10 Clorane Gardens
London, NW3 7PR

Basement Impact Assessment
Audit

London Borough of Camden

Project Number: 12336-11

FOUNDATIONS/LOWER GROUND FLOOR PLAN

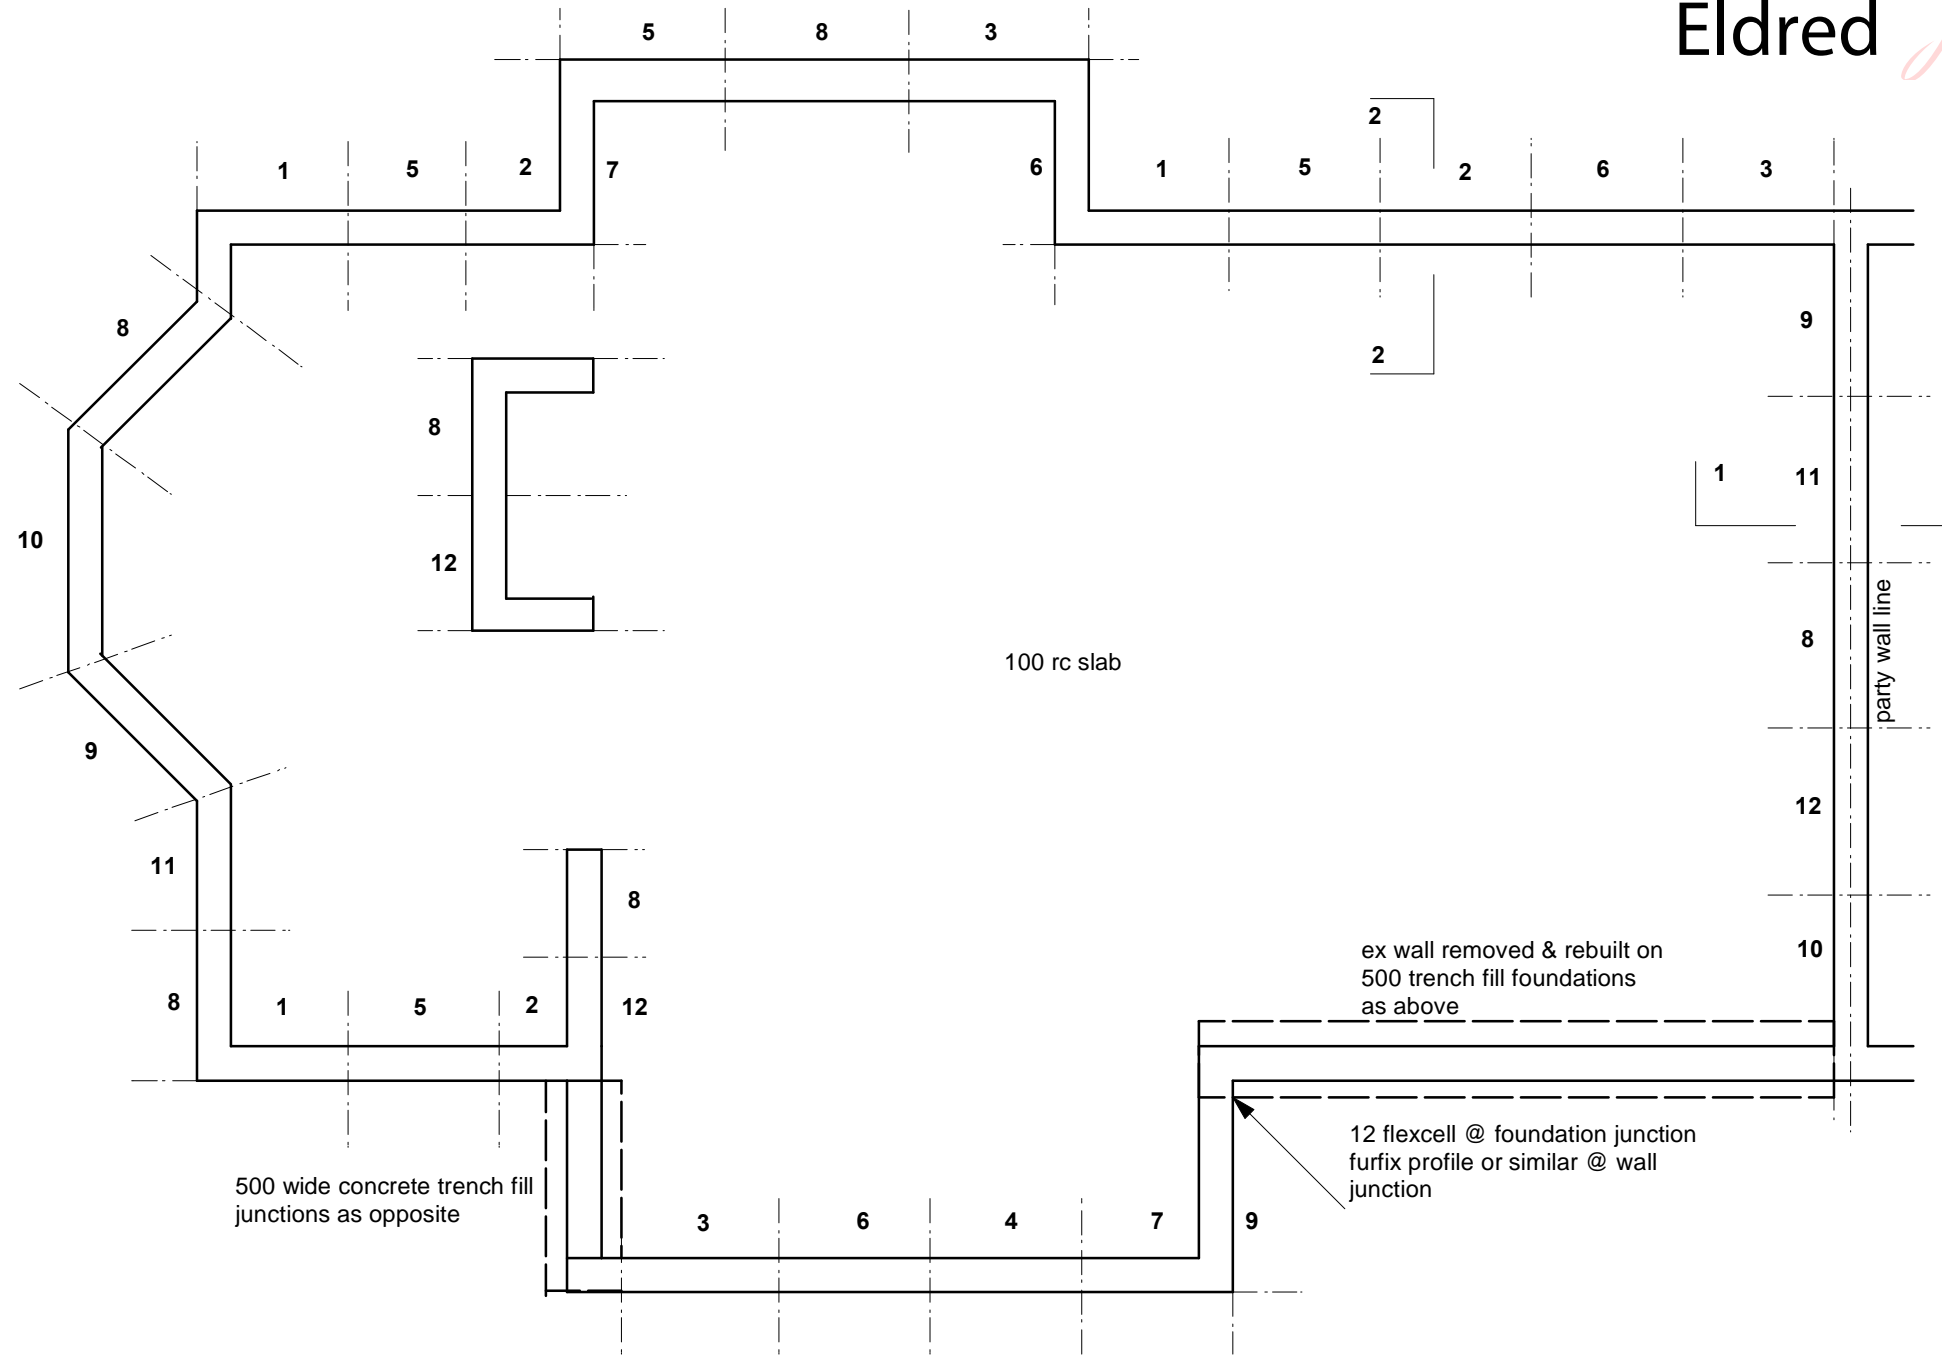
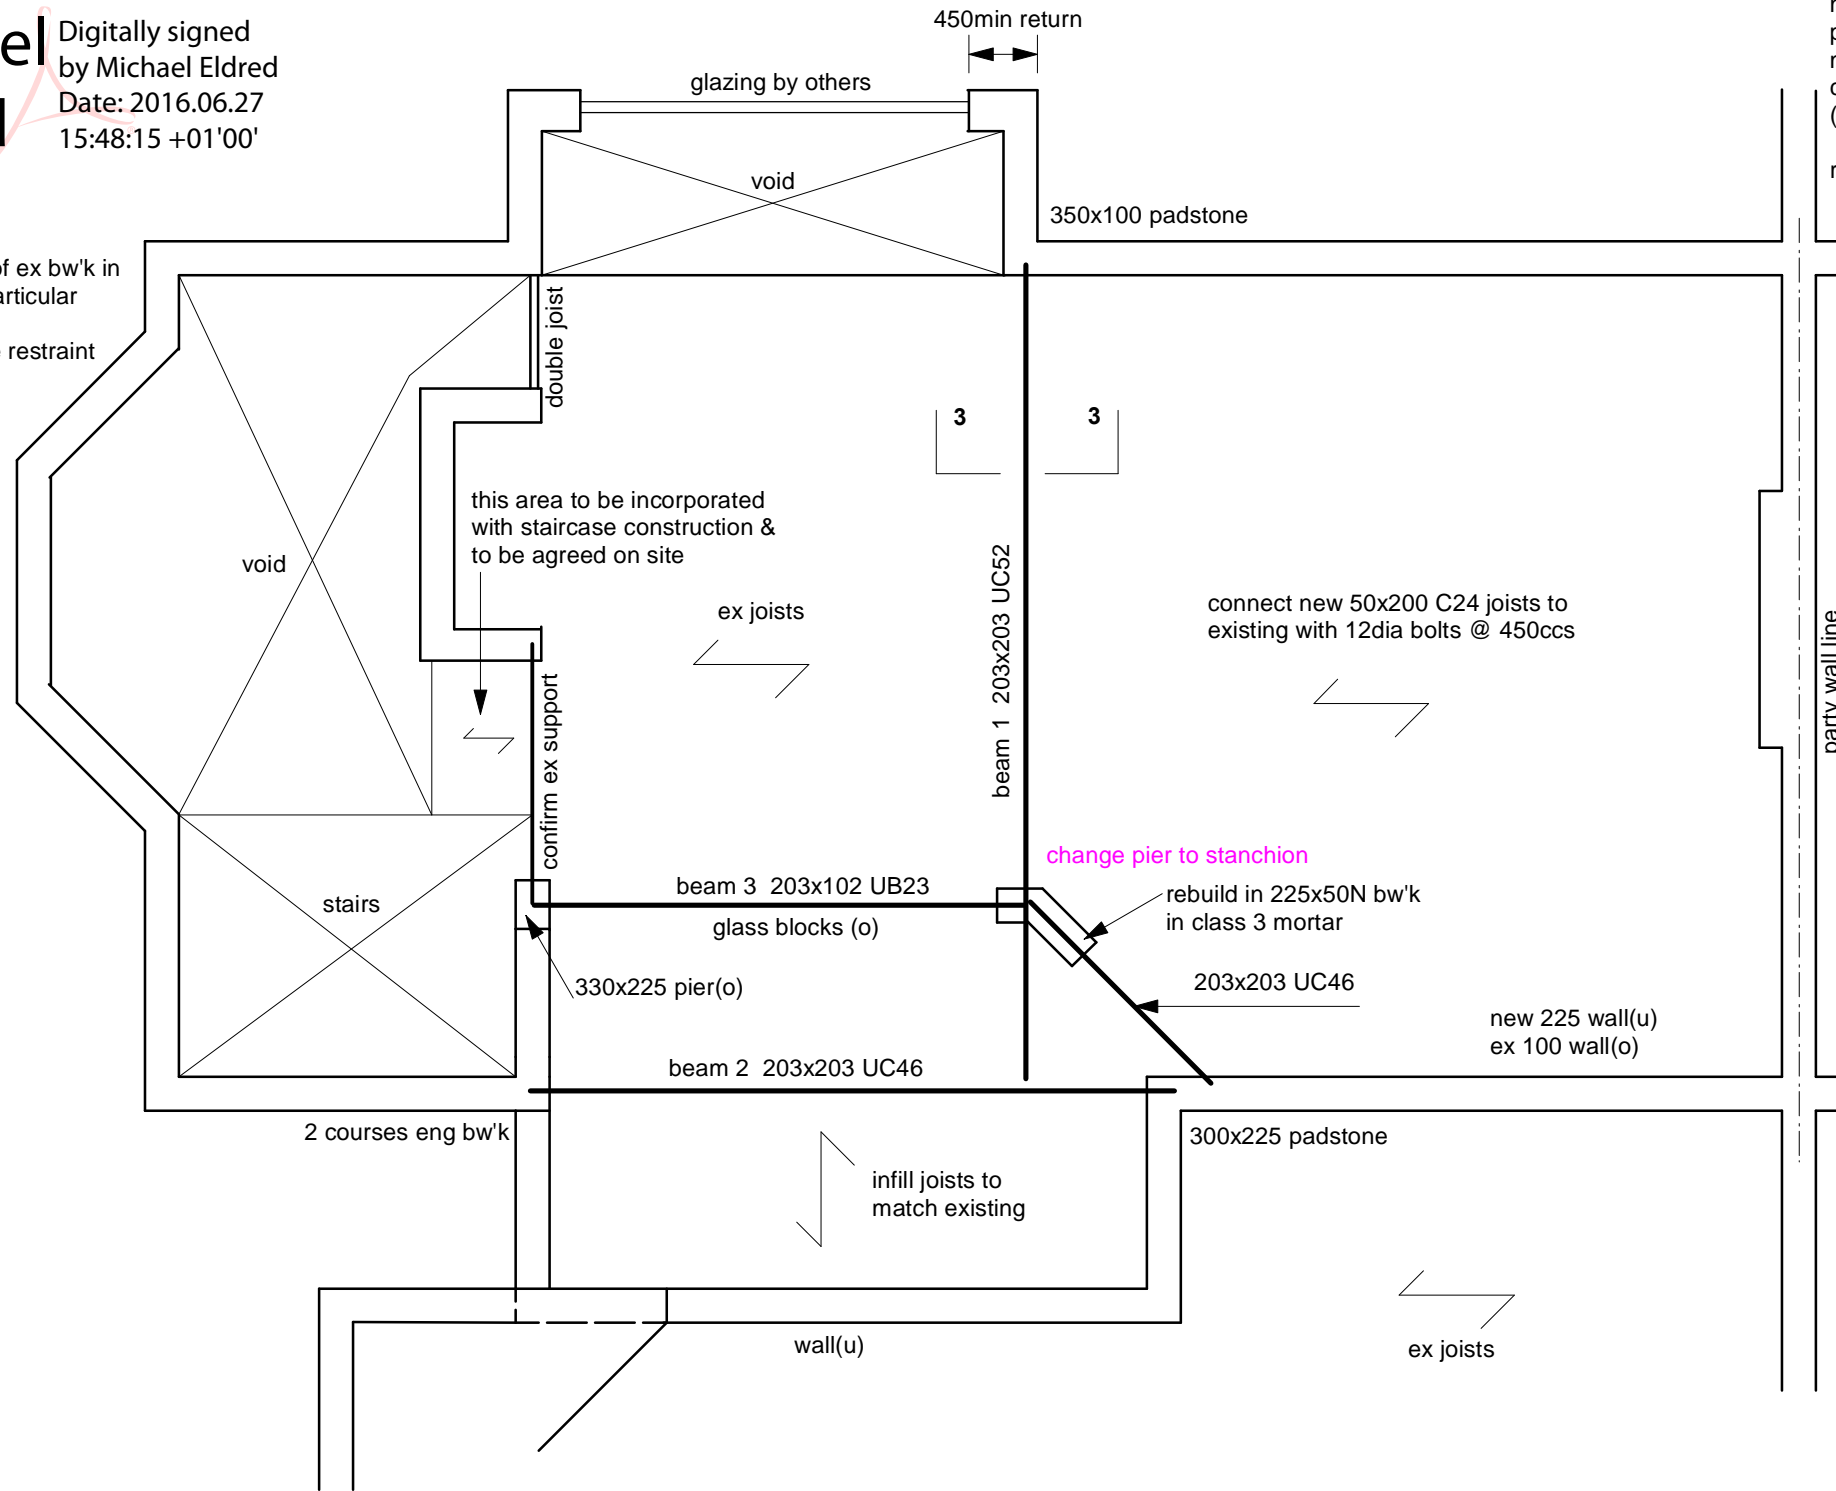
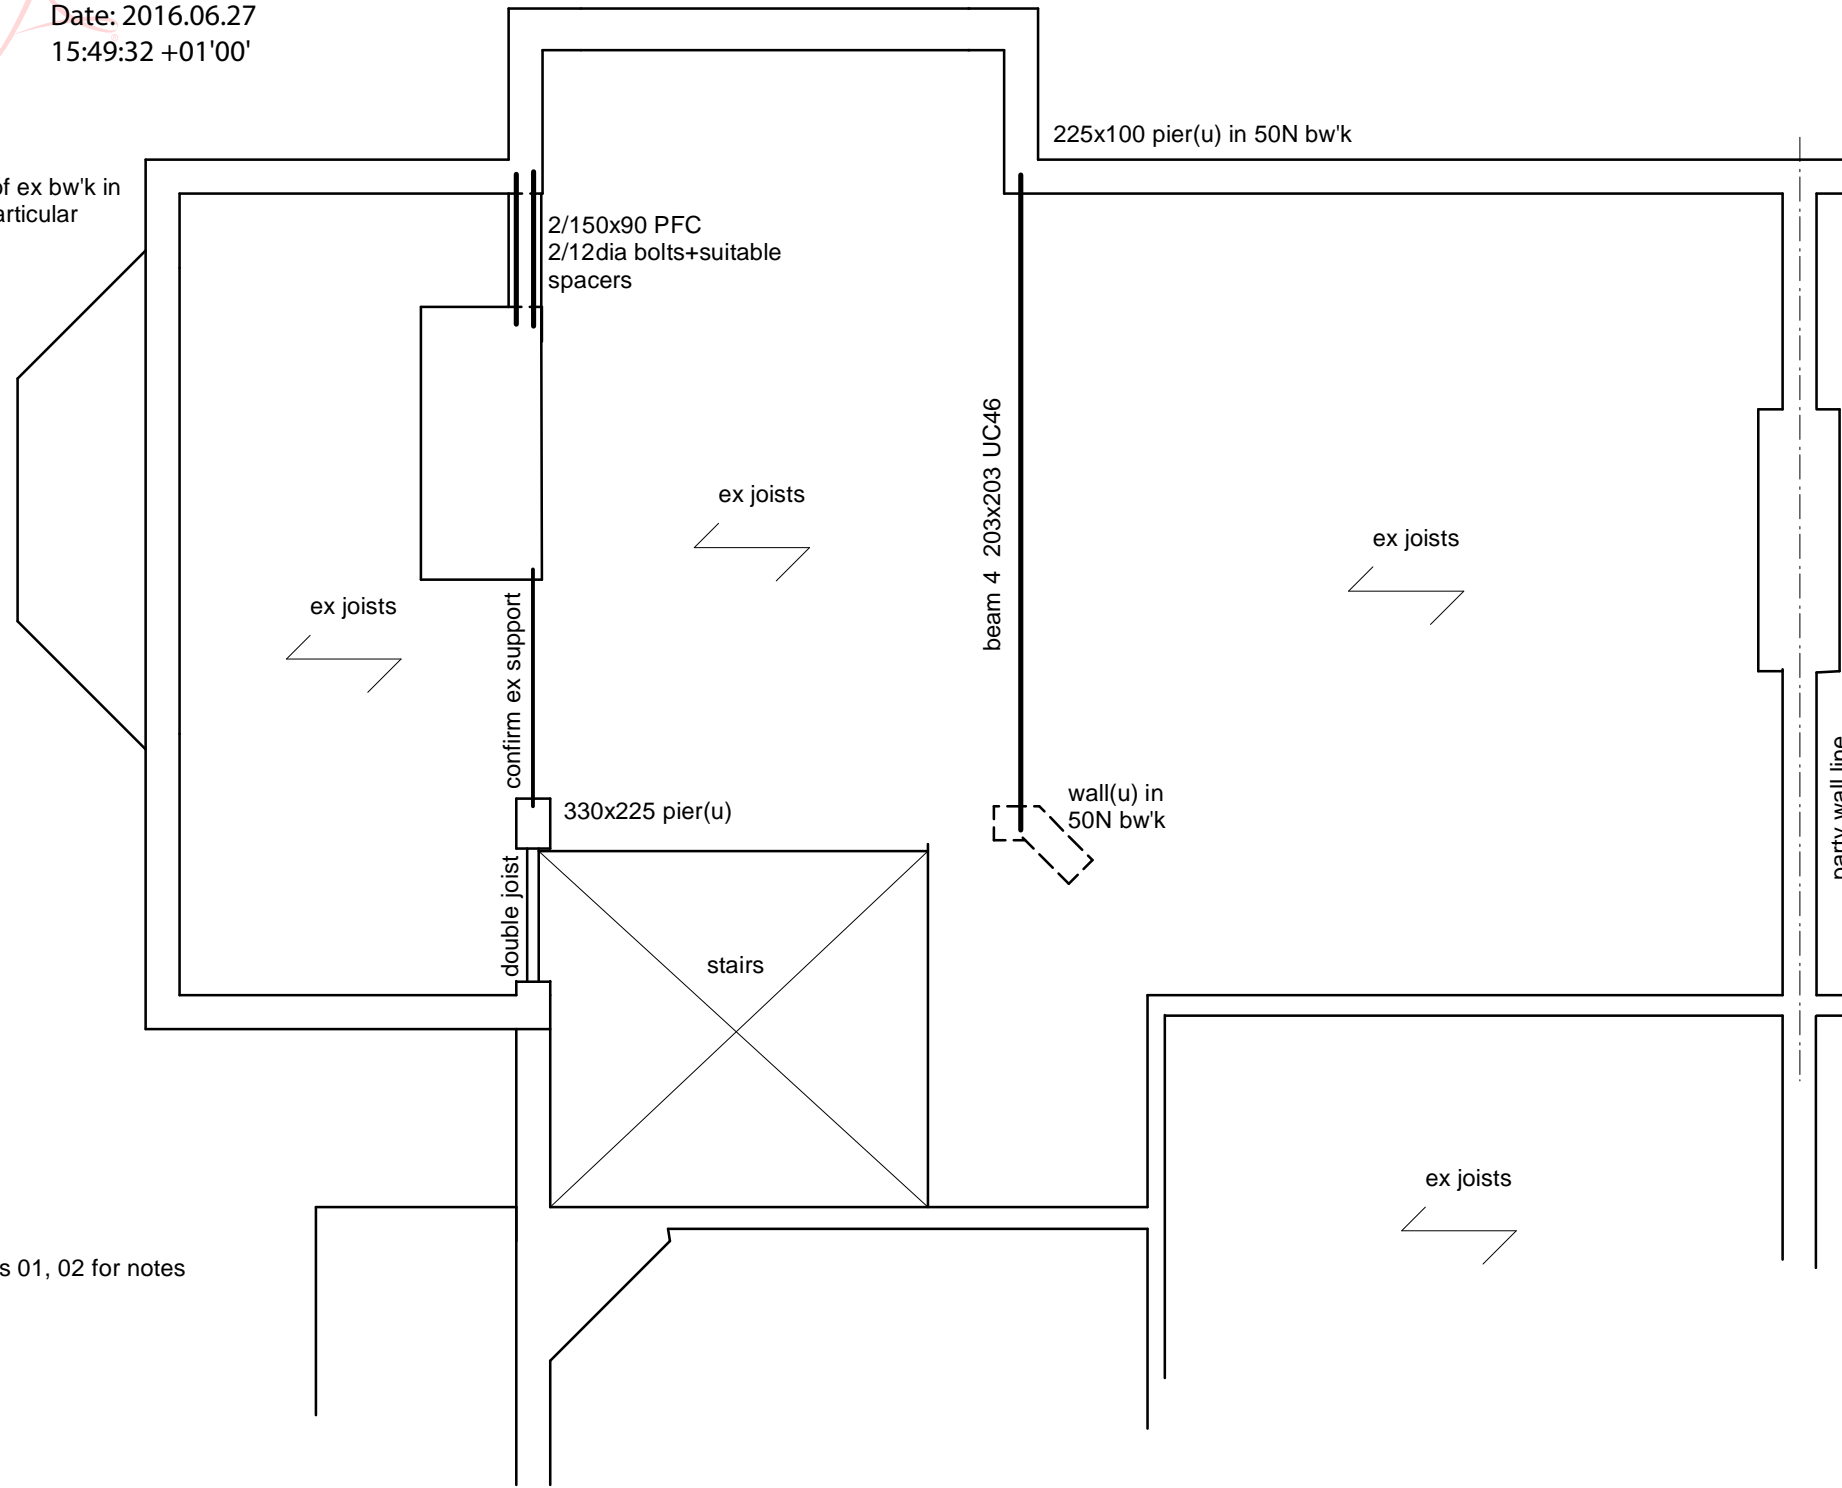
- 4.17. The Eldred Geotechnics Technical Advice note dated 26th February 2016 provided on behalf of No 12 Clorane Gardens queries the damage assessment to the southern wall of No 12 due to the presence of a partial basement to this elevation of that property. In their response to this report, Gabriel GeoConsulting highlight that usual good practice would suggest the underpinning is stepped beyond the extent of the basement. Were this stepped underpinning to be present, it would reduce the effects of the proposed construction of an adjoining basement and, hence, reduce the differential settlements experienced by No 12 and any consequential damage. It has subsequently been confirmed that no such stepping exists, however, a further ground movement/building damage assessment (see Appendix 3) confirmed that it should be possible to limit any damage to Burland Category 1 on the basis that workmanship is well controlled and the affected buildings are in sound condition.

- 5.8. It was requested that as built details of the existing foundations to No 12 be determined to enable the potential for differential settlement to be determined. This information was provided

Stuart Eaves has asked me to send this response directly to you. Following my conversation with Liz Brown of Campbell Reith this afternoon, and receipt of the attached rather basic drawings for No.12's underpinning from Buicon (Party Wall Surveyors), here is our response in relation to Campbell Reith's outstanding query concerning the predicted damage category for the flank wall of No.12.

The structural drawing of the underpinning for No.12's basement (Drg No.06194-01 by David A Berle Consulting Engineers, dated July 2006) shows no evidence of any transition underpins beneath the front part of No.12's flank wall. Thus, we must assume that the front 3.8m section of this wall remains supported by its original foundations, which were assumed in the BIA to be founded at the same 1.45m depth below ground level (bgl) as the footing to the front wall of No.12. This lack of stepping-up does not comply with normal good building practice. The depth of excavation for the basement below the level of the footings to No.12's flank wall would therefore be about 2.3m, and the horizontal distance between the basement and these footings widens from 1.83m at the front corners of the houses to 4.2m at the front corner of No.12's basement.
